**Car Stereo
Service Bulletin**

Model: RM-X2

No.120R1

Subject: Volume Changes Too Drastically

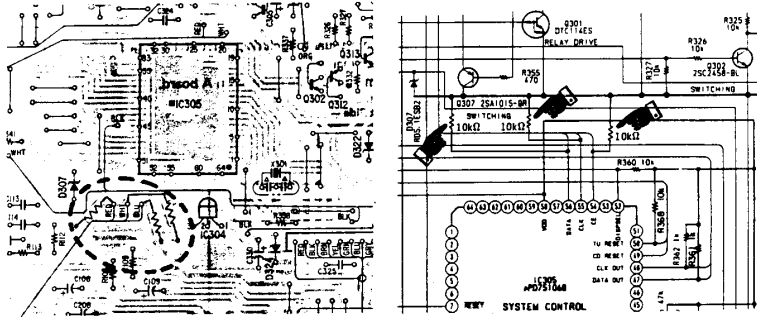
Symptom: This Service Bulletin Supersedes Service Bulletin No. 120 (52)
There is a large change in volume when the volume display switches from the third to the fourth step.

Solution: 1. Replace the microprocessor IC with a new one.

Ref. No.	Description	Part Number	
		Former	New
IC305	Microprocessor	UPD7510G-532 8-759-142-02	UPD-7510G-541 8-759-142-1B

2. Add 10k resistors to the CE, CLOCK, and DATA lines after replacing IC-305. These are Pins 54, 55, and 56 respectively.

Description	Part Number
10k Ohm 1.6W Resistor	1-249-429-11

3. Short Pins 27 and 28 of IC305 together.
